ANN ARBOR HISTORIC DISTRICT COMMISSION

Staff Report

ADDRESS: 903 West Huron Street, Application Number HDC24-0089

REPORT DATE: June 13, 2024

Undated interior photos from Zillow of 903 W Huron #1 (Note the glass block kitchen window that faces the rear parking lot, and the grey chair cushions (?) hanging from a cupboard in both photos. The window with the box fan is the one that was converted into a door.)

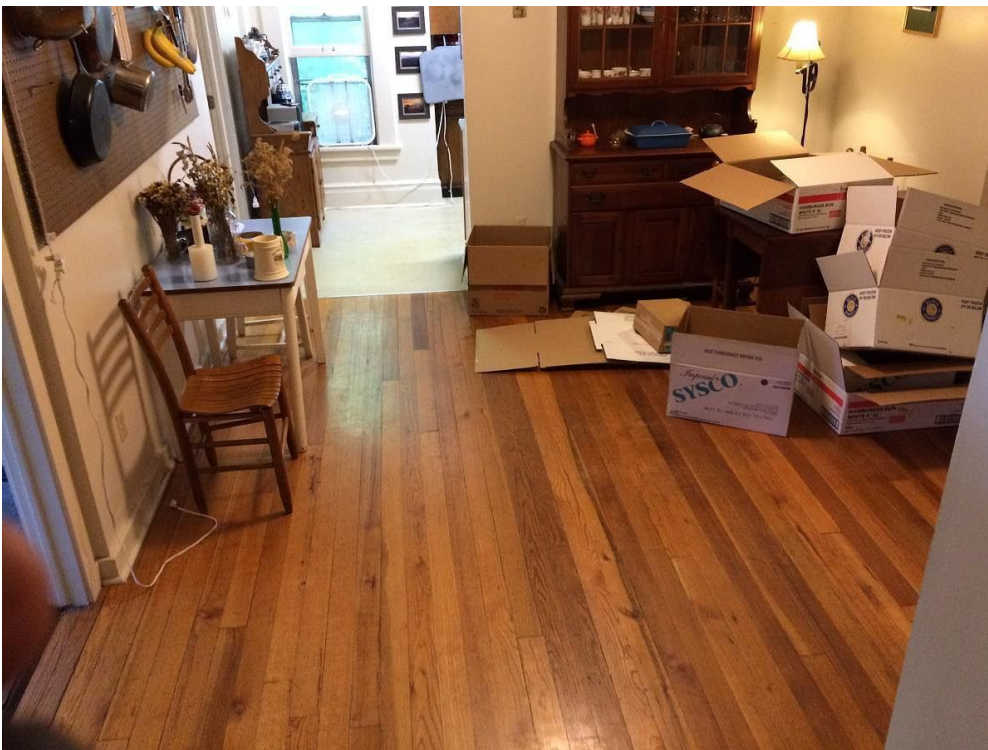
3. On the south elevation of the house, visible from the public right-of-way, work was begun to replace a window with a door. The only historic material remaining after this work is the former window's pedimented crown. The trim that enframed the window on the sides has been removed. The window opening was made larger to accommodate a steel door and a narrow, disproportionate transom window. The door and transom are framed by underlayment or tar paper. The intended design or method to finish this trim is unknown.
